Safety Defect and Noncompliance Report Guide for Vehicles  
**PART 573 Defect and Noncompliance Report<sup>1</sup>**

Furnish the manufacturer's identification code for this recall (if applicable): EQD-004

Make(s): NUWA Model Years Involved: 2004 Model(s): Premier, Discover America, Champagne Edition

Vehicle Type: Recreational Trailer Bodystyle: Fifthwheel

**Attachment "2"  
Page 1 of 2**

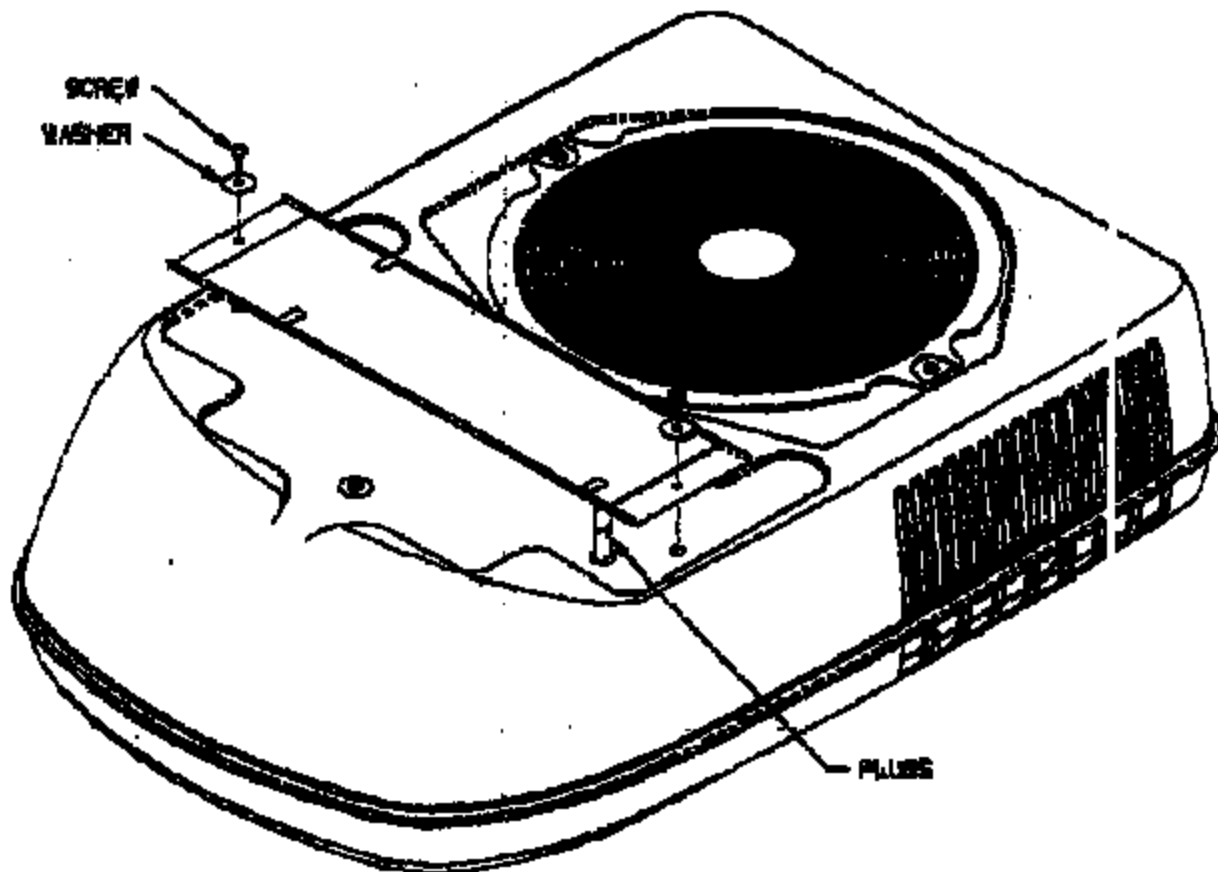
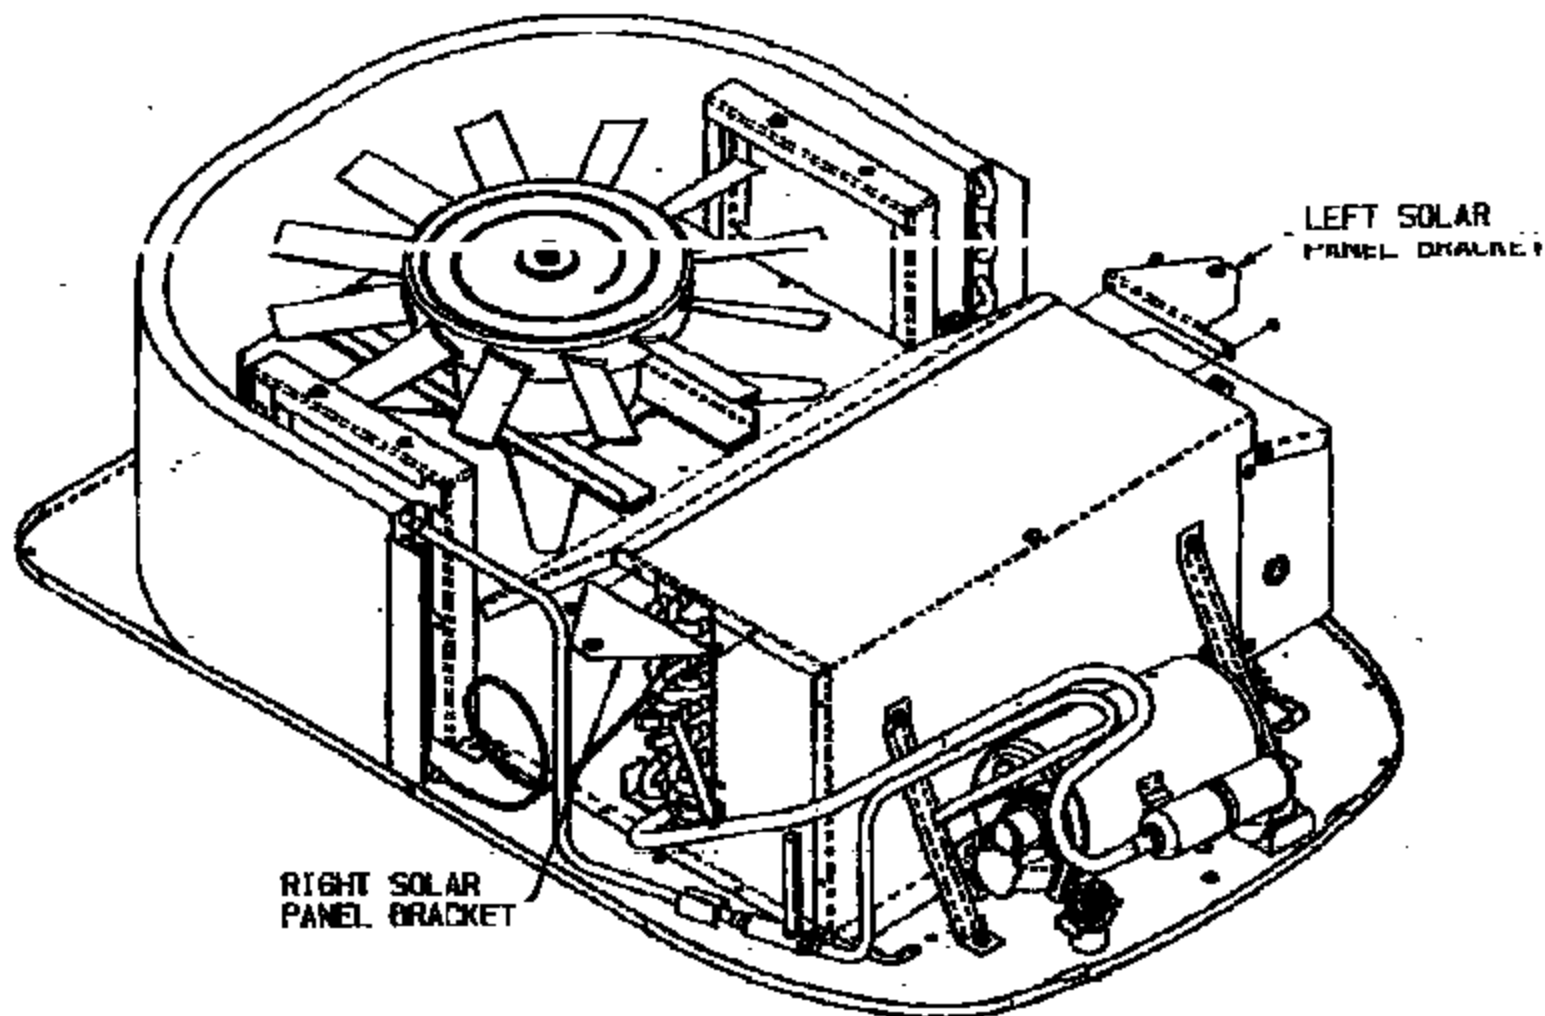
**Airxel's description: The original mounting system (see Attachment "1") utilized two well nuts (rubber expansion plugs with a threaded insert) to attach the solar panel to the air-conditioner shroud.**

**Describe the cause(s) of the defect or noncompliance condition. Airxel's description: In some instances the rubber well nuts fractured the plastic shroud in the immediate area of the attachment hole. In other instances the rubber well nuts may not have engaged the hole adequately to prevent them from being pulled out of the plastic shroud during normal use.**

Airxcel's has eliminated the well nut fastening system and the solar panel is connected directly into threaded inserts located in two metal brackets attached to the internal metal housing of the air-conditioner.

- C. Re-assemble the two screws and washers through the holes in the solar panel plate and into the threaded inserts of the rooftop unit. Initially start the screws by hand to prevent cross-threading. Using a philips screw driver or a electric drill with a philips bit, tighten the screws until solar plate rests snug against the shroud.

1. REMOVE SOLAR PANEL, FAN GRILLE AND SHROUD FROM UNIT.
2. ADD SOLAR PANEL BRACKETS TO UNIT AS SHOWN ABOVE BY USING EXISTING SCREWS.
3. RE-INSTALL SHROUD TO UNIT GUIDING UNIT SOLAR CABLE THROUGH HOLE IN SHROUD AS SHROUD IS BEING INSTALLED.
4. RE-INSTALL SOLAR PANEL WITH SCREWS THREADED INTO SOLAR PANEL BRACKETS.
5. RE-INSTALL FAN GRILLE.
